APRIL 2021

TRAILS AT ASPEN RIDGE				
ROADWAY & STORM IMPROVEMENT PLANS ROADWAY & STORM PLANS				
ROAD CENTERLINE KEY MAP				
DESIGNED BY:	TRC	SCALE	DATE ISSUED:	APRIL 2021
DRAWN BY:	LCB	HORIZ. 1" = 80'	SHEET	4 OF 50
CHECKED BY:	NMS	VERT. N/A		
				DRAWING No. RD00

TRAILS AT ASPEN RIDGE
FILING NO.3
ROADWAY & STORM IMPROVEMENT PLANS

PARK INLET
SCALE: (H) 1" = 40' (V) 1" = 5'
START STA: -0+25.00, END STA: 2+00.00

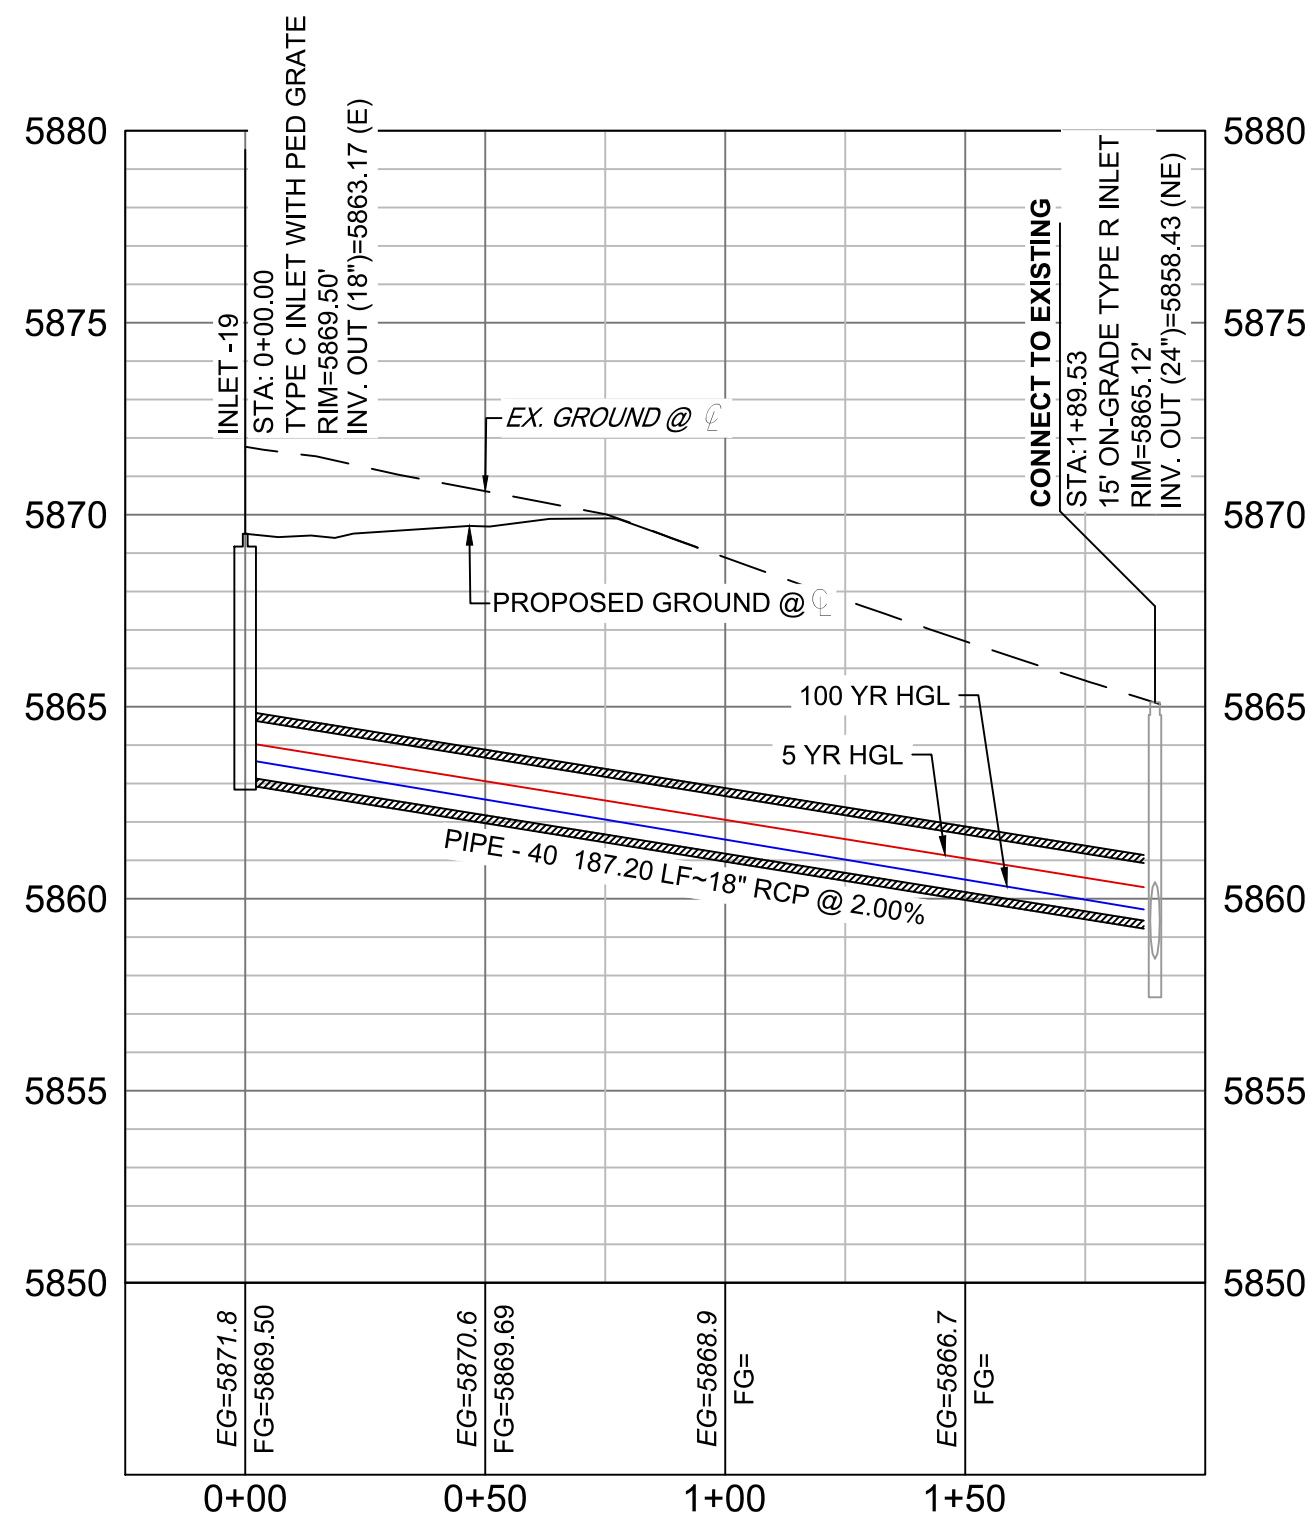
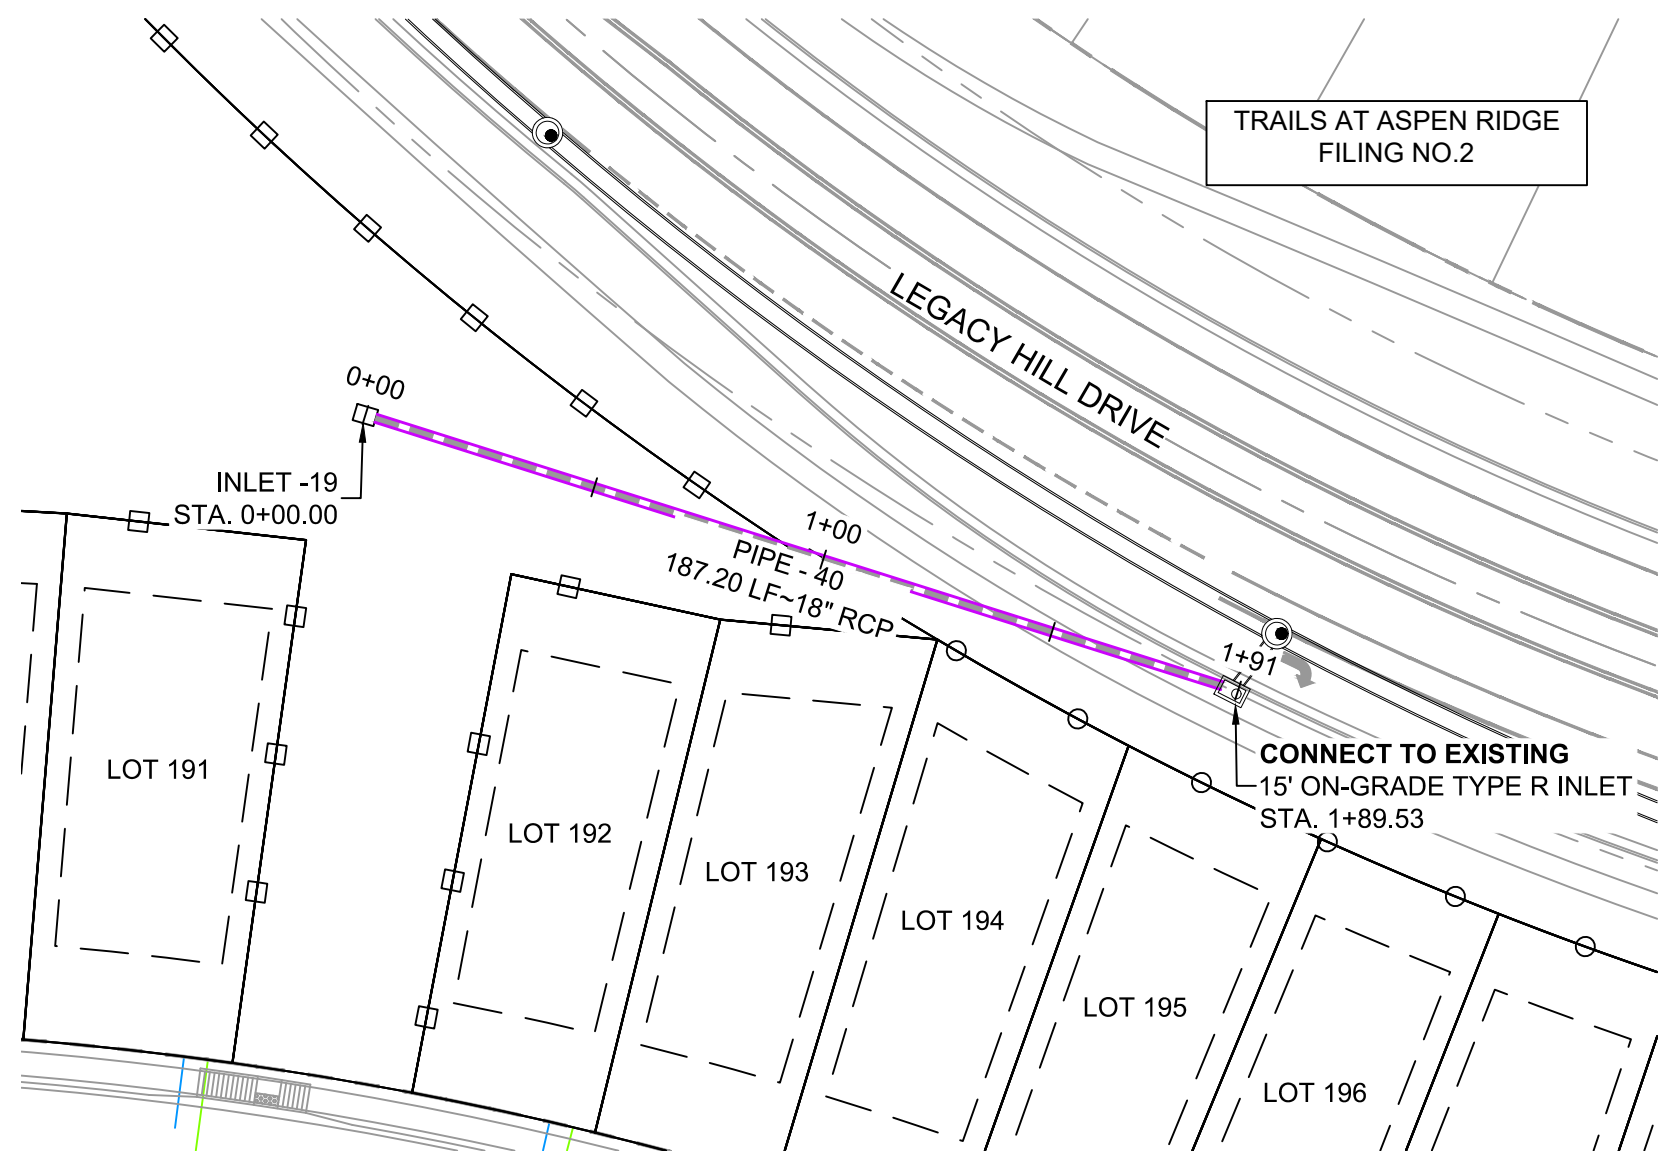
update HGL based on future Q due to the additional note to be added below

Add the following note:
Sections of storm pipe with pressure head during the 100yr storm shall use watertight joints with a 100 yr service life per ECM 3.3.1.D
